PLAN FOR PROPOSED BUILDING ON PLOT NO. 64, RB. II.

KARACHI MUNICIPALITY.

REFERENCE No. B. S. P. 283 OF 1932

Re Building ~~XXXX~~ on plot No. 64, R.B. 11, Rambaugh.

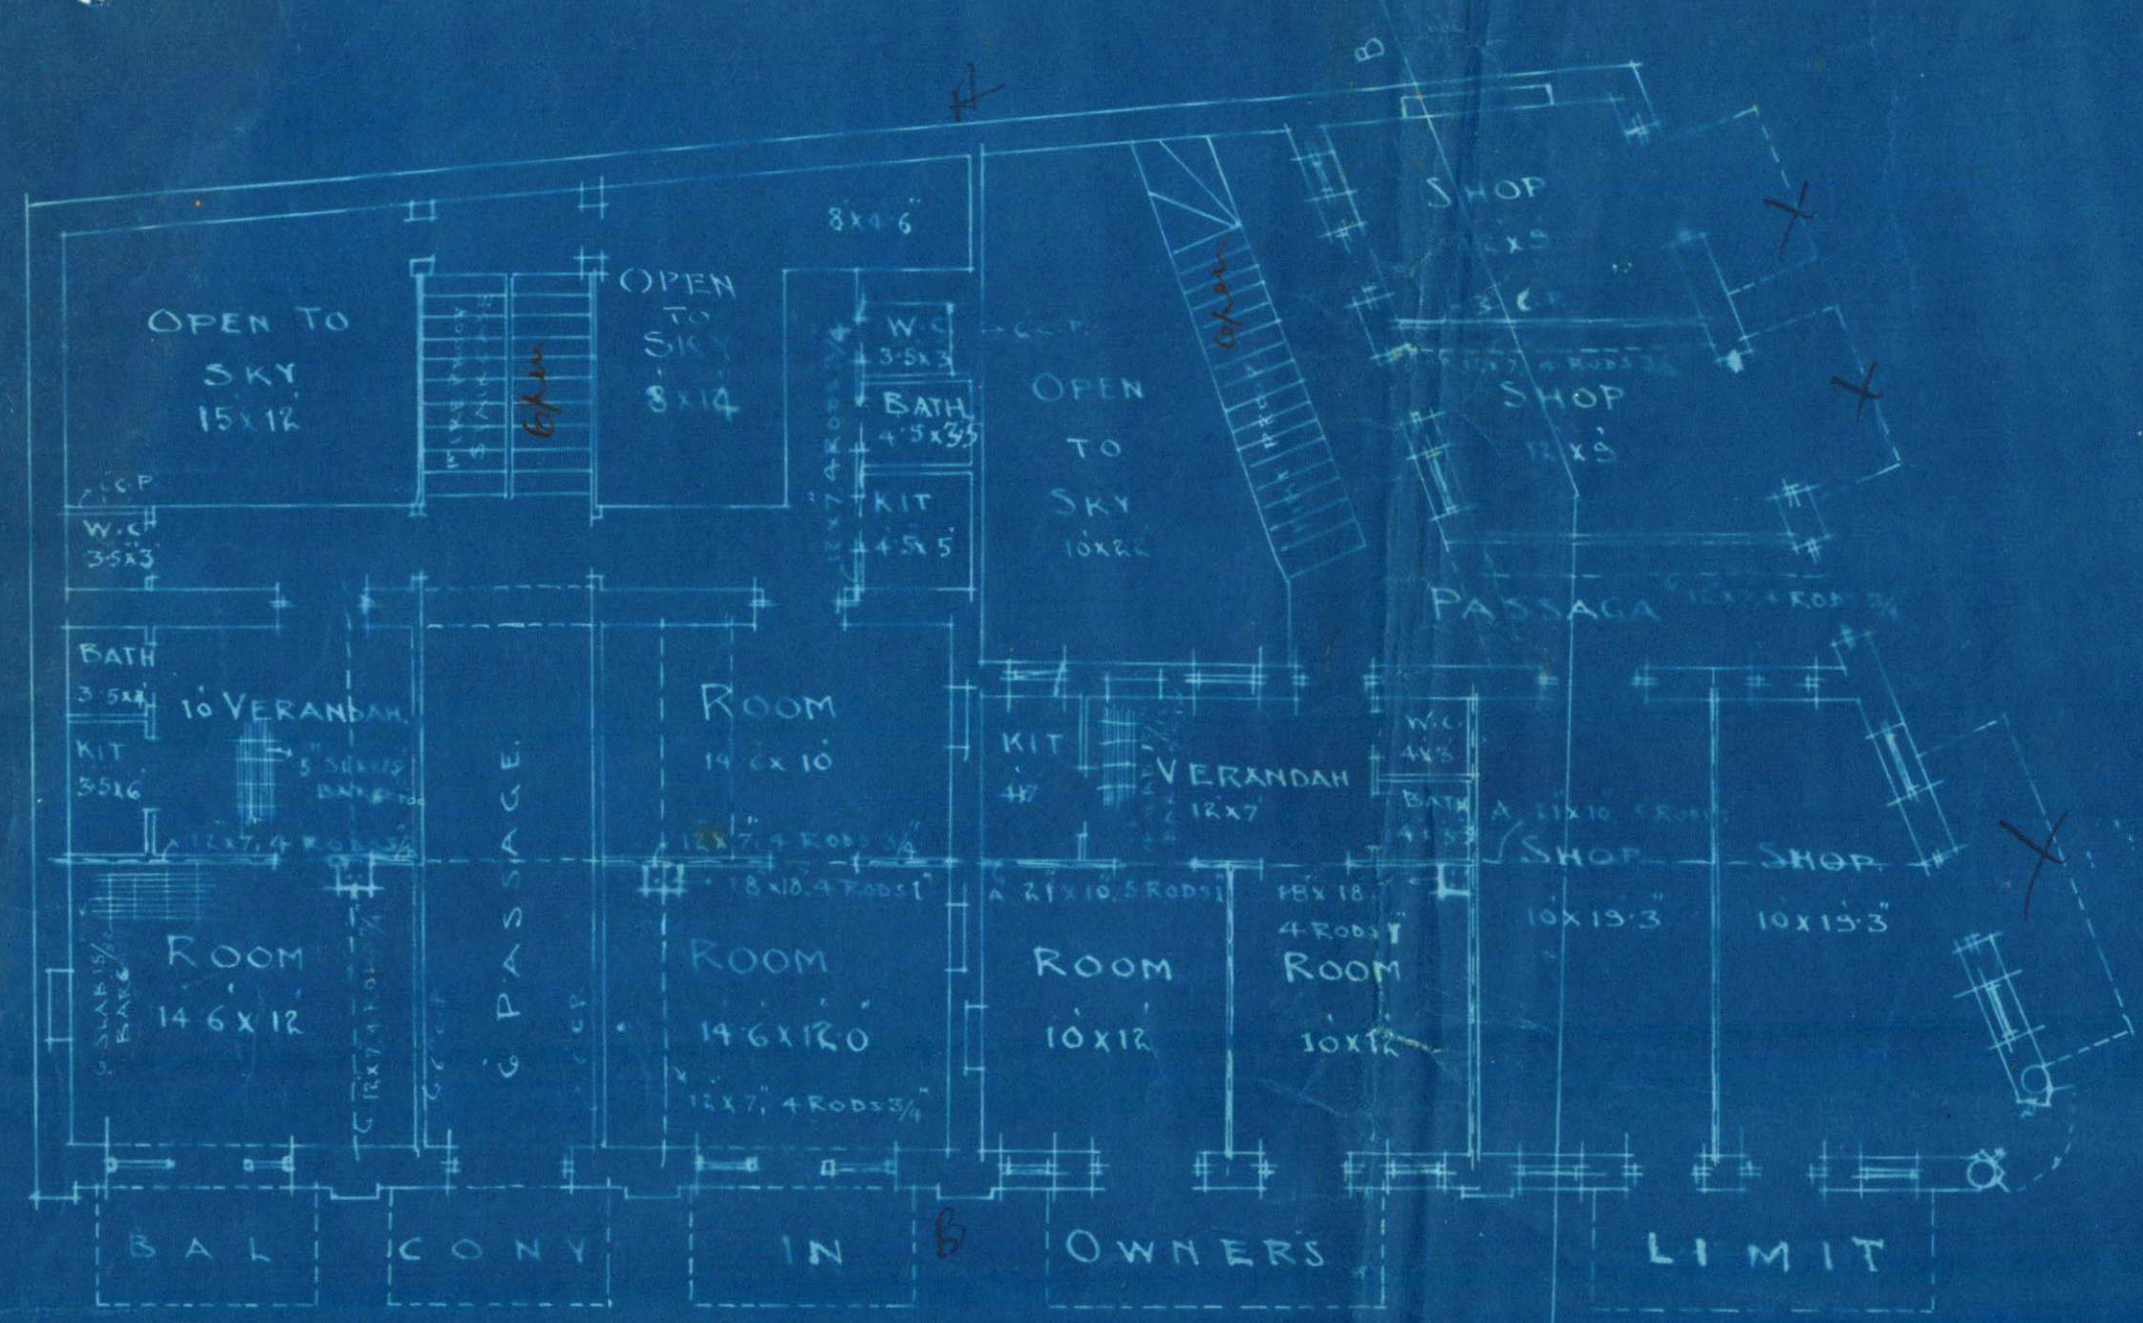
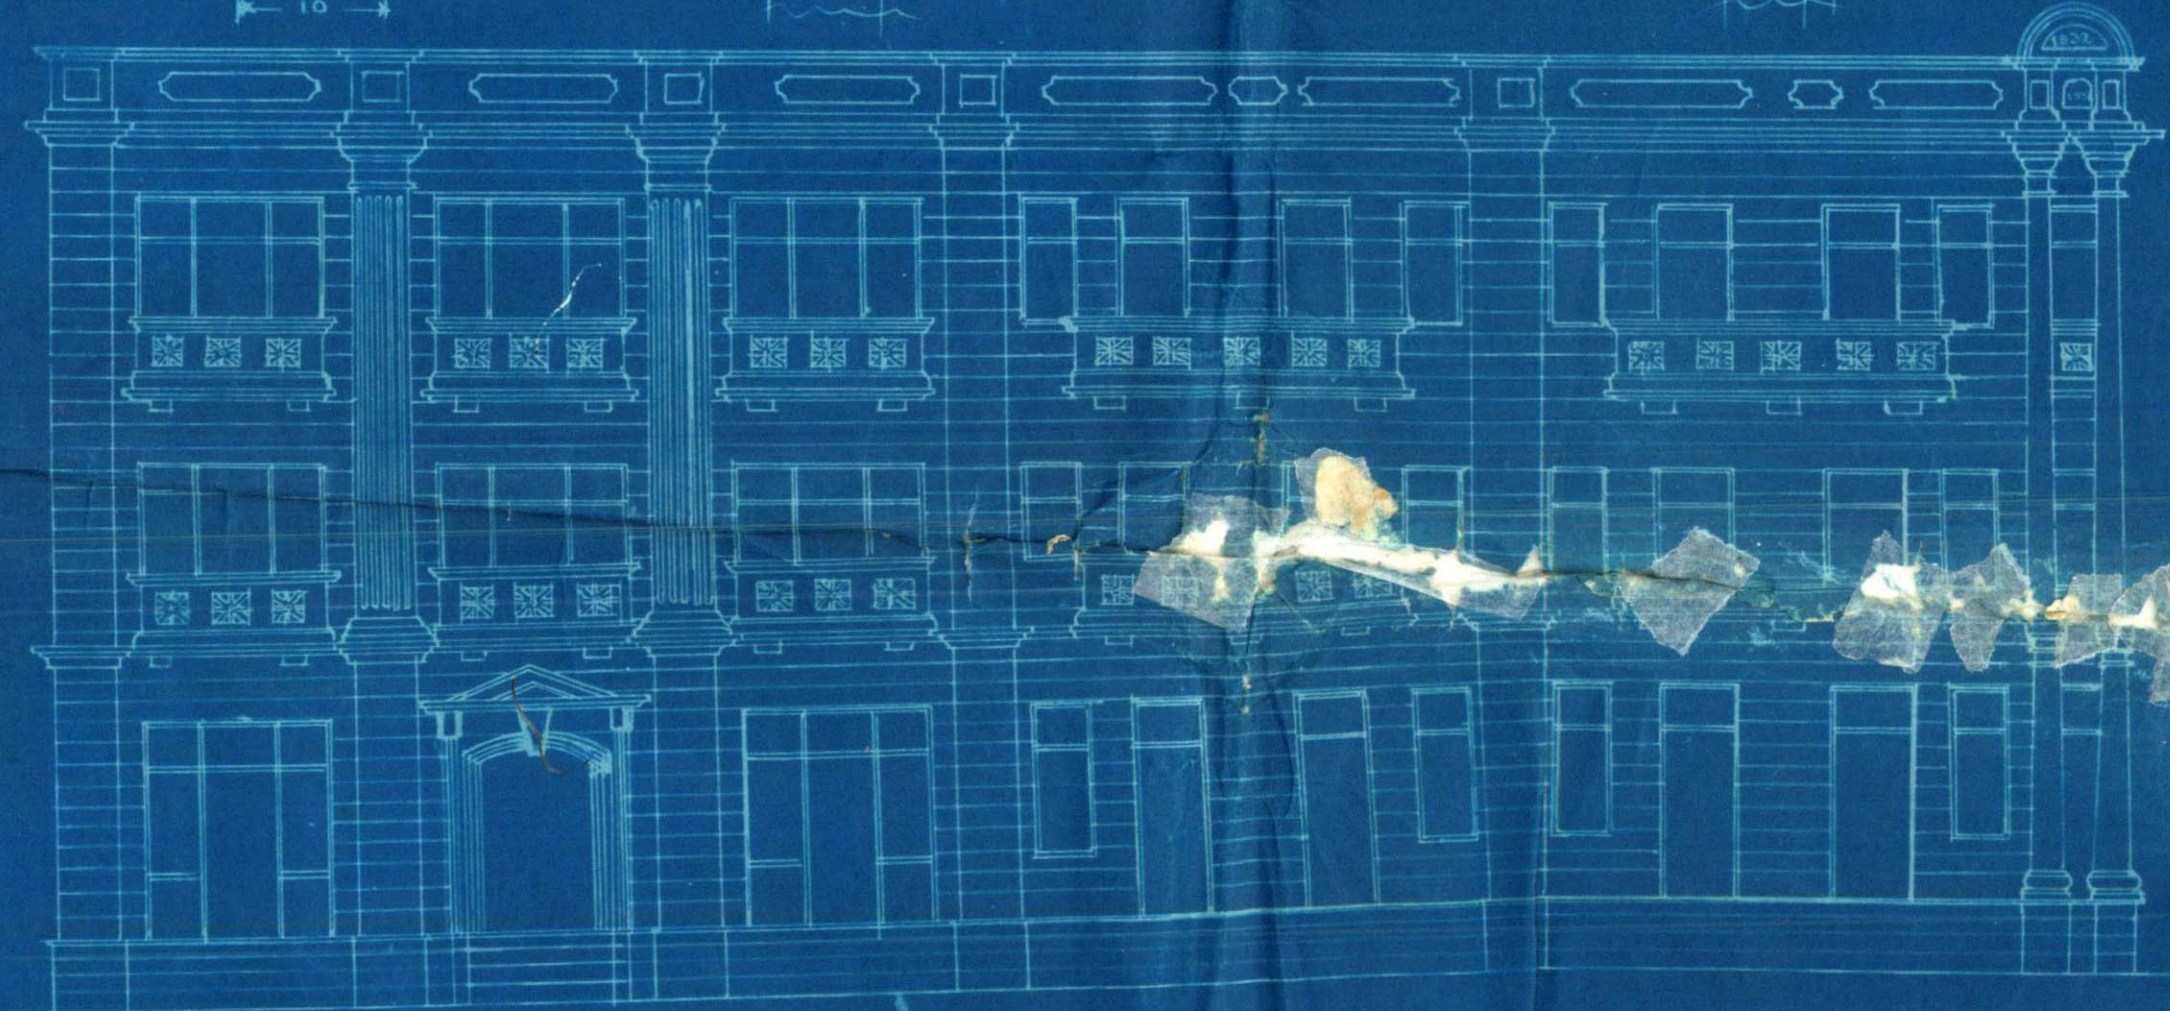
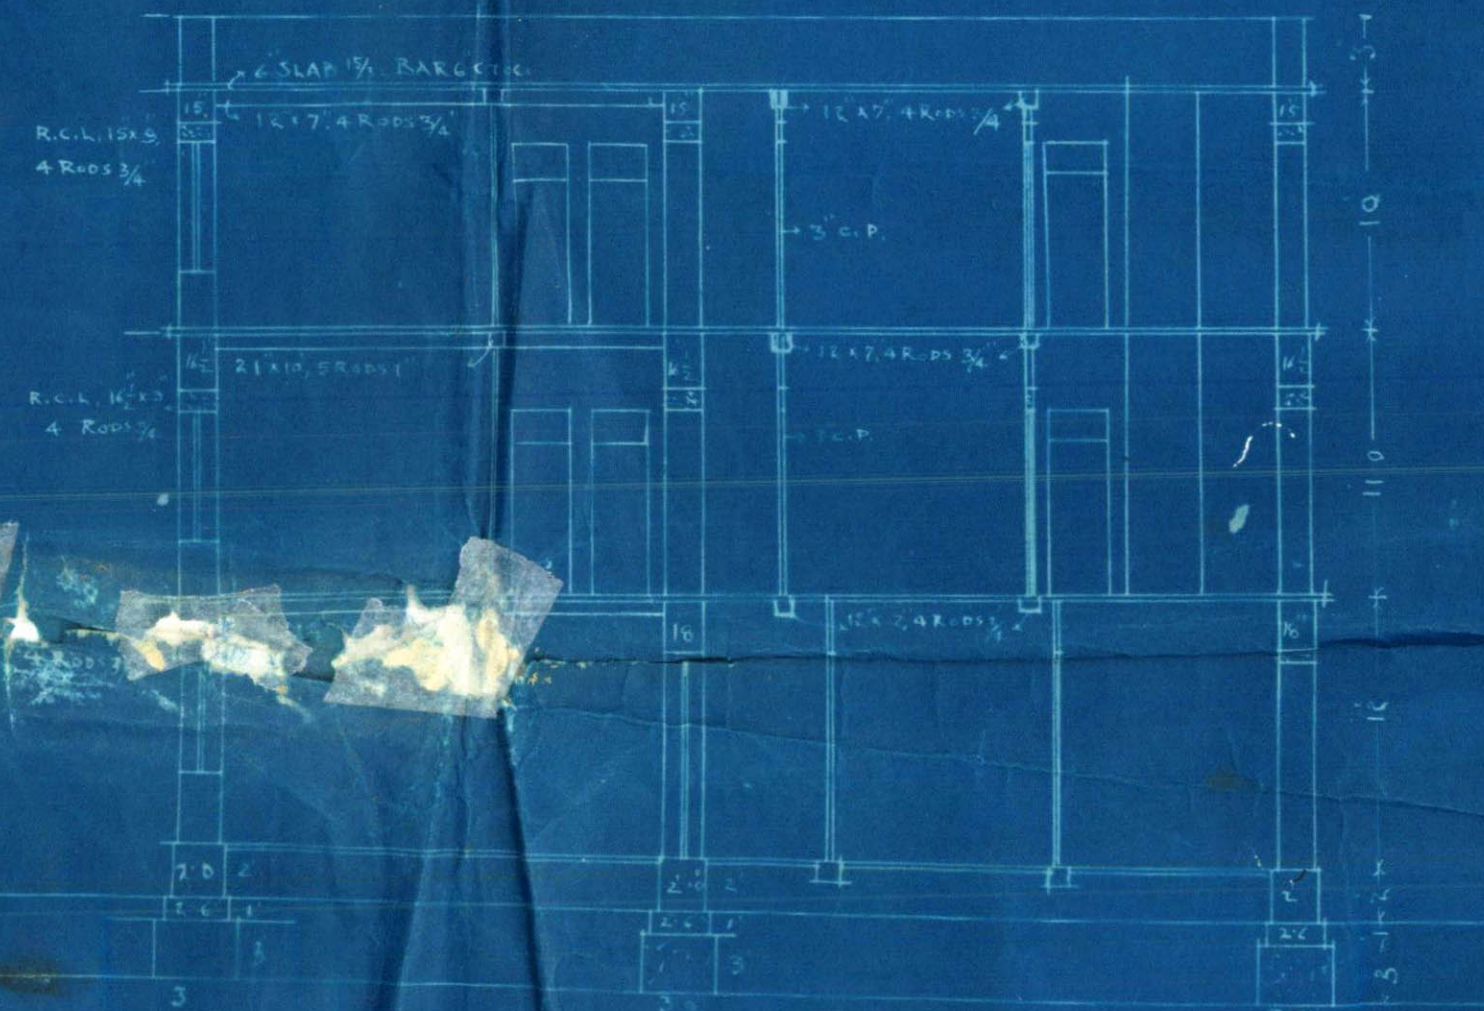
Not Objection balconies in the Delites Ramkrishna Temple and
is less than 50', BS 2 3 (4) 5, 6, 7 & 8
Veranda means half the wall in the open. 12x5 & 12x10
Room within of this wall should be kept at right angles
open space in the room by large & broad
Access to the balcony, begins from the open area.

- ✓ (1) Balconies must be deleted. Randa under temple
- ✓ (2) Road is less than 50' Details of built up area must be given
- ✓ (3) Passage A to be 6'
- ✓ (4) The staircase to be written down as open staircase
- ✓ (5) Windows to be shown
- ✓ (6) Window to be provided at P
- ✓ (7) Passage P between kitchen + verandah to be at least 3'
- ✓ (8) Details of R.C.C. staircase to be given
- ✓ (9) Verandah means half the wall must be open
- ✓ (10) 12x9 + 12x10 room instead of being kept open be kept at right angles
- ✓ (11) Open space must be shown by length & breadth & calculations be given for the open area
- (12)

All the objections have been complied with excepting
to doors instead of being kept skew be kept at
right angles

Further this plan is proposed to be subdivided
into two portions - Can the wall A-B be
allowed to be a party wall or both are
plans should have independent walls of
full thickness.

- ① For the Veranda B Screen: put up against the w.c.
- ② For Veranda B^{ic} Position of w.c. and kitchen is changed -
- ③ The objection that the ~~screen~~ walls be at right angles as no screen remains unaccounted with. Orders are refused.

The design is very messy. Why does he not diminish the fenestration - I care about being w.c. + bath tucked in a Paroche which will serve as sink or sitting room. 23/7

- (1) The design is very miserly.
- (2) Why don't you diminish your dimensions.
- (3) I can't allow kitchen, wc & bath.
- (4) I would like a passage which will be used as dining or sitting room.
- (5)
- (6)
- (7)
- (8)
- (9)
- (10)
- (11)
- (12)

He must submit a revised
Plan eliminating all the objections explained to the
B.G.
